STAFF RECOMMENDATION 1406 Fifth Avenue North October 17, 2018

Application: Partial Demolition; New construction—Additions
District: Germantown Historic Preservation Zoning Overlay
Council District: 19
Map and Parcel Number: 08209008800
Applicant: John Root, Architect
Project Lead: Melissa Baldock, melissa.baldock@nashville.gov

Description of Project: Application is to demolish non-contributing portions of the house, and to construct a front porch and rear additions. The rear addition is proposed to be eight feet, four inches (8'4") taller than the historic house. The Commission approved the proposed partial demolition and the new additions in decisions from 2015 and 2016, but these preservation permits have since expired. In addition, the design guidelines have changed since that decision.

Figure 7 shows the contour elevations for the lot.

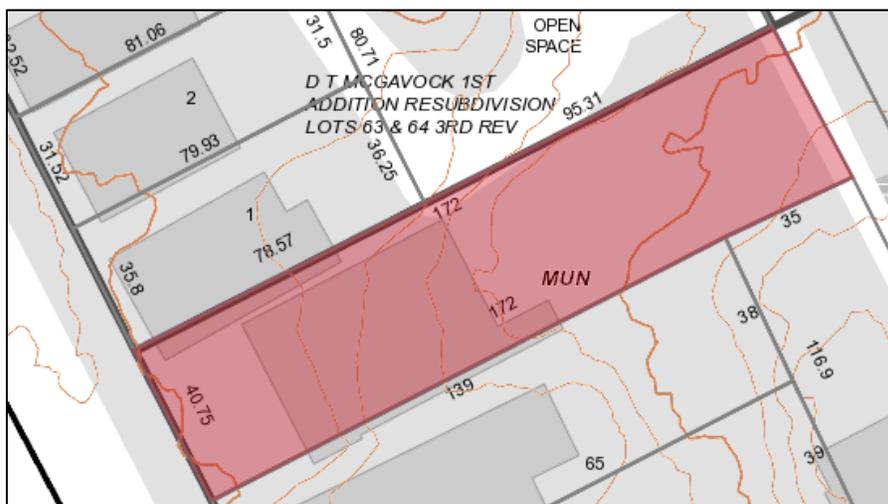
Examining the proposed addition under the current Germantown design guidelines, staff finds that its insets, width, depth, and footprint meet the design guidelines. The height of the addition, however, does not meet the current design guidelines. The previous Germantown design guidelines did not discuss situations when additions could go taller than the historic house; they did not provide a maximum additional height or parameters for when taller additions would be appropriate. Many of the other MHZC design guidelines for residential neighborhood conservation and historic preservation zoning overlays state, in italicized print, that an addition may extend up to four feet (4') taller than the historic house at a distance forty feet (40') back from the front of the house. In the 2015 staff recommendation, staff recommended that because the addition was more than fifty feet (50') back from the front of the house, the addition should be limited to being five feet (5') taller than the historic house. However, the Commission approved the addition to be eight feet, four inches (8'4") taller because of the slope of the lot.

The current design guidelines now state, in italicized print, that “*when a taller addition is the only option,*” additions can be up to four feet (4') taller than the historic house at a point forty feet (40') back from the front of the house. Staff finds that an addition that is taller than the historic house could be appropriate for this lot because of the slope of the site. The site is steeply sloped upwards towards the back of the lot; there is a difference of about ten feet (10') from the front of the lot to the rear (Figure 7). The lot’s ground is rock, making it difficult and expensive to dig and level the slope. However, staff is not supportive of the proposed height of the addition which is a two-story addition on a one-story house. Since the current design guidelines specifically limit the height of additions to be no more than four feet (4') taller than the historic house, staff recommends that the addition be reduced in height by four feet, four inches (4'4”) in order to meet the current design guidelines. Staff finds that the proposed rear addition’s height is out of scale with this one-story with a raised basement house, and that reducing the addition’s height to be no taller than four feet (4') taller than the historic house would make the addition more compatible with the historic house.

With the condition that the addition be reduced in height to be no taller than four feet (4') taller than the historic house, staff finds that the proposed addition meets Section V.2. of the design guidelines.

1. The addition be no taller than four feet (4') taller than the historic house;
2. Staff approve a brick sample and roof shingle sample;
3. Staff approve the location of the HVAC unit and all utilities; and
4. Staff approve all permanent landscape features, included but not limited to fences, pathways, pavers, parking pads, pools, etc.

Figure 8. The 1897 Sanborn map shows the brick portions as pink and the frame construction as yellow. The rear and right/south facades were not 80% brick.

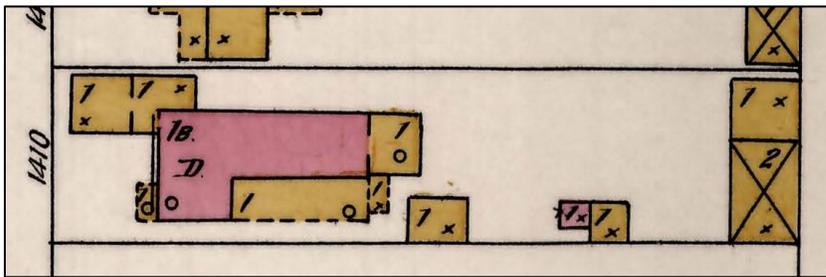
*The design guidelines state that "All facades shall be at least 80% brick. A greater percentage of accent materials may be used on facades that are not visible from a public right-of-way." The applicant is proposing an addition that is entirely clad in siding,

making the left/north façade fifty-two percent (52%) brick and the right/south façade forty-seven percent (47%) brick. The rear façade is almost entirely siding, with only the two feet (2') of brick walls at the back of the historic house being brick. Staff finds that in this case, having an addition that contains no brick is appropriate because historically, the historic house had substantial amounts of non-brick facades. Both the 1897 and the 1957 Sanborn maps show that the entire back of the house was frame and not brick and that about two thirds of the right/south façade was an enclosed wood porch (Figures 8 & 9). Parts of that wood porch section are now brick. Since historically, appendages and additions to this historic house were frame and not brick, staff finds that the proposed lap siding material to be appropriate for the addition. Staff finds that the percentage of brick on the side and rear façade to be in keeping with the historic character of 1406 5th Avenue North.

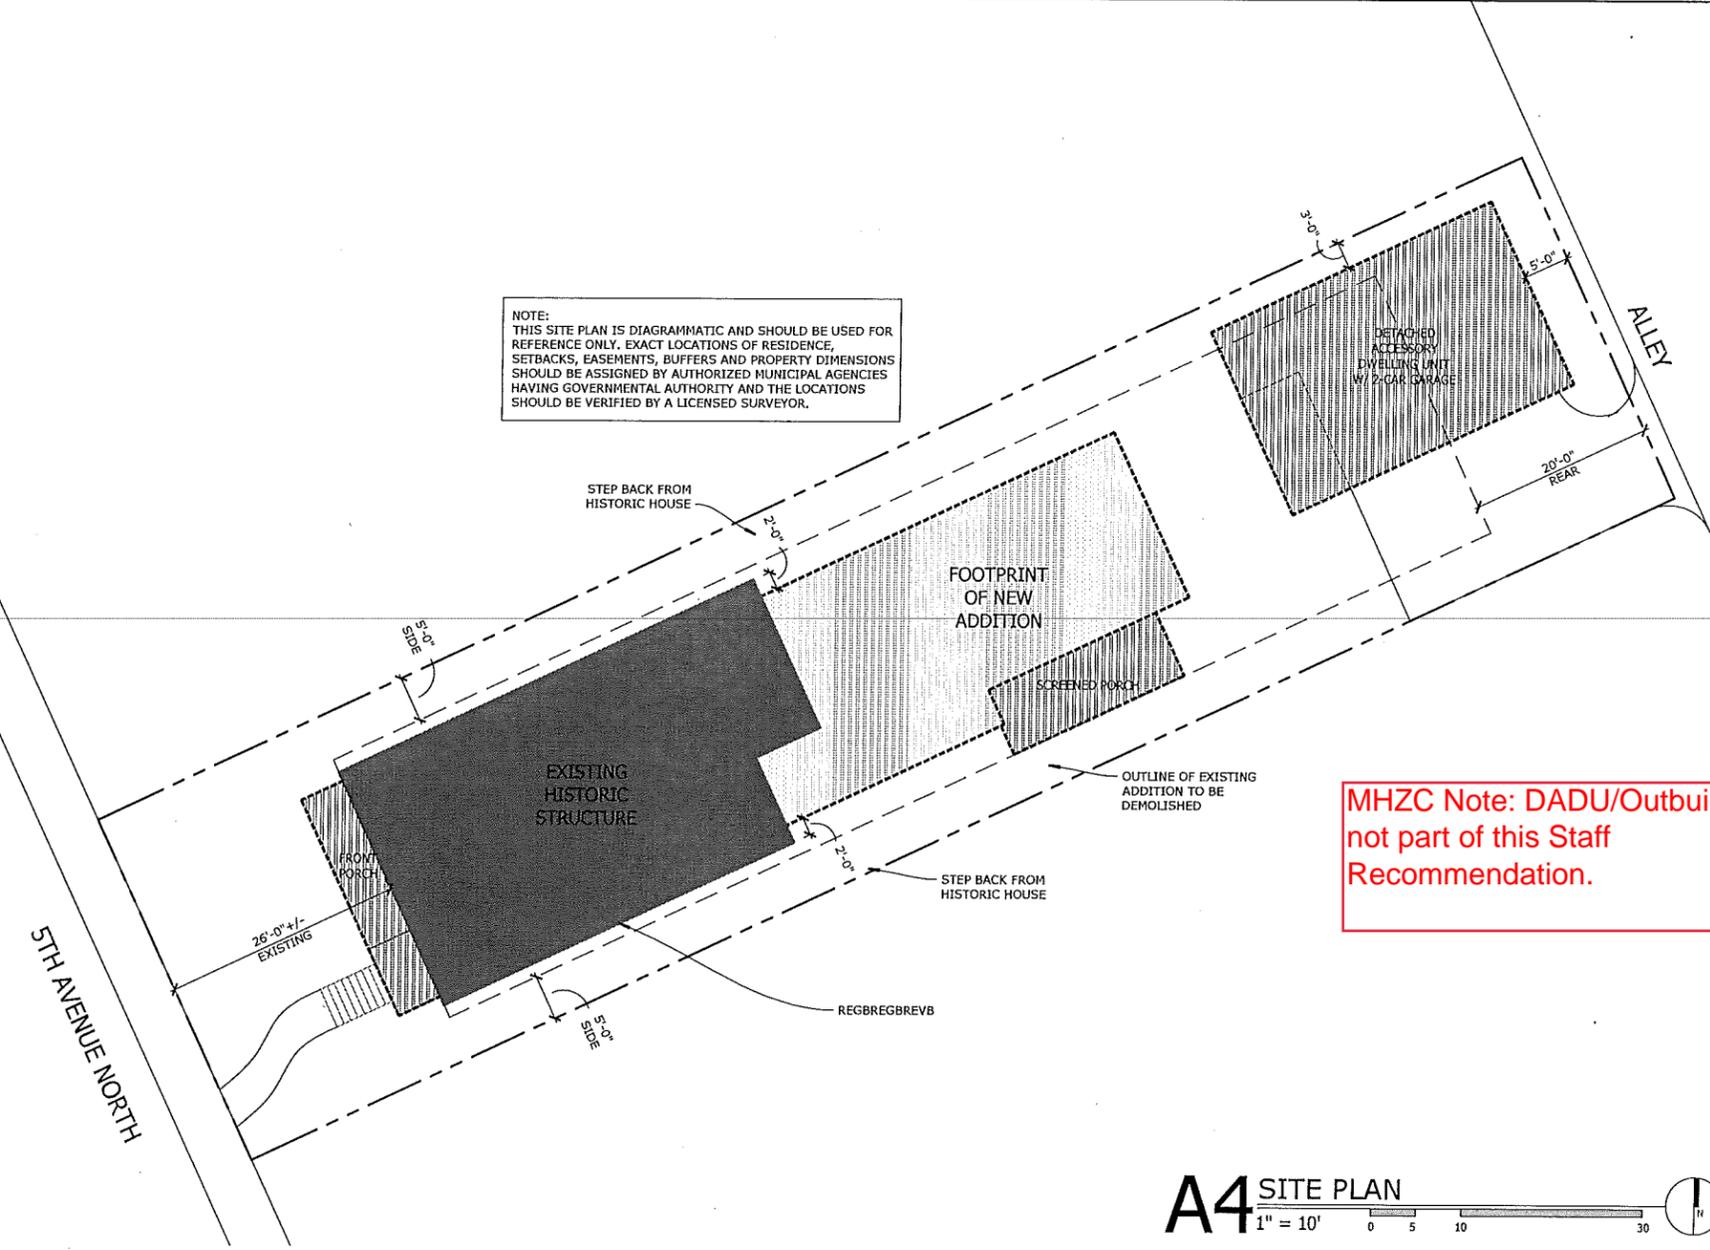
MHZC Note: DADU/Outbuilding not part of this Staff Recommendation.
